NEI 99-02 FAQ 20-05
RBS Unplanned Scram May 2019 – Proposed NRC Response

Plant: River Bend Station, Unit 1
Date of Event: 5/31/2019
Submittal Date: October 09, 2020
Licensee contact: Timothy Schenk Tel/email: 225-381-4177 / tschenk@entergy.com
NRC Contact: Raymond Kumana Tel/email: 817-200-1970 / rkuma94@entergy.com

Performance Indicator: IE04 - Unplanned Scrams with Complications (USwC)

IE04 Unplanned Scrams with Complications - Flowchart
Figure 2

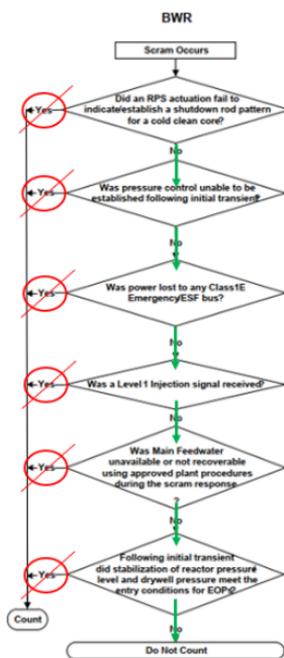
Based upon the above timeline and NEI 99-02 Rev. 7 definitions, RBS was outside the "Scram Response Time" by 30 minutes before the subsequent level three scram signal and therefore did not have an Unplanned Scram with Complications. Additionally, the below flowchart demonstrates this conclusion as seen in NEI 99-02 Rev.7, Figure 2.

The resident inspectors believe the May 31, 2019 scram is an unplanned scram with complications based on answering “Yes” to NEI 99-01 Revision 7, “IE04 Unplanned Scrams with Complications – Flowchart” questions #5 and #6.

On Question #5, “Was main feedwater unavailable or not recoverable using approved plant procedures during the scram response”, the resident believes the answer is “Yes.” The resident takes the word “recoverable” in the sentence to mean recoverable in a sustainable manner. Main feedwater was not recoverable in a sustainable manner using approved plant procedures because approved plant procedures did not instruct operators to un-isolate the heater string when bringing the feed pump back online. In using approved plant procedures, operators failed to un-isolate the heater string during their initial start of the feed pump. Consequently, when they secured the condensate pump per procedure, they caused the feed pump to trip, resulting in a low-level scram signal and an EOP re-entry.

On Question #6, “Following initial transient, did stabilization of reactor pressure/level and drywell pressure meet the entry conditions for EOPs?”, NEI 99-02 offers the following clarifying guidance:

The guidance clearly indicates that the scope of the question includes the period after the plant has been initially stabilized and EOP's have been exited, where operators are stabilizing the remainder of the plant to allow for the use of normal operating procedures. The station was in that period when the second EOP entry occurred. Due to the abnormal feed system lineup that the station implemented during the initial response and stabilization, an abnormal condition developed in a scram response related vessel parameter—specifically, reactor vessel level—that required re-entry into EOPs.

Based on our review, it was determined that the licensee was still in the “Scram Response” window when the second scram occurred and did not meet the ‘and’ condition within the “Scram Response” definition that states in part, “*and concludes when operators have completed the scram response procedures*”, per NEI 99-02, Rev. 7.

The event details gathered from discussions with the inspectors revealed that the reactor feedwater system alignment was not prescribed in approved plant procedures, as they were operating the ‘C’ feedwater pump on isolated heater strings. As a result of this event, the licensee subsequently identified the reactor feedwater system alignment as an invalid alignment and updated plant procedures to address it. Even if the staff were to have considered the reactor feedwater system lineup as proceduralized, the second ‘C’ feedwater pump trip revealed that the reactor feedwater system was not in a stable configuration. Because the reactor feedwater system was in a lineup not covered at the time by approved plant procedures and that lineup was not stable in that it resulted in the ‘C’ feedwater pump trip, the staff determined that the reactor feedwater system could not be considered recovered. Therefore, the answer to question #5 would be ‘Yes’ and would make the classification of this scram event an USwC.

In this event, after the licensee experienced the first ‘1A and 1C’ feedwater pump trip on low suction and inserted a manual scram as a response, the operators restarted the ‘C’ feedwater pump, but failed to un-isolate the ‘B’ heater string, which caused the ‘C’ feedwater pump to trip on low suction pressure for a second time. This second ‘C’ feedwater pump trip caused a full RPS actuation on reactor vessel Level 3 and required a second entry to EOP-001, “RPV Control.” The criteria in this question is used to verify that there were no other conditions that developed during stabilization of the plant in the scram response related vessel parameters that required continued operation in the EOPs, re-entry into the EOPs, or transition to a follow-on EOP. Because the operators were attempting to restart the ‘C’ feedwater pump without the correct alignment, which resulted in a second automatic scram and re-entry to EOP-1, the answer to question #6 would be ‘Yes’.

In conclusion, upon reviewing the event details, prior applicable FAQs, and discussing the circumstances surrounding the May 31st, 2019 reactor scram, the staff determined that this event should be classified as an Unplanned Scram with Complications (IE03). No changes to NEI 99-02 needed as a result of this FAQ.
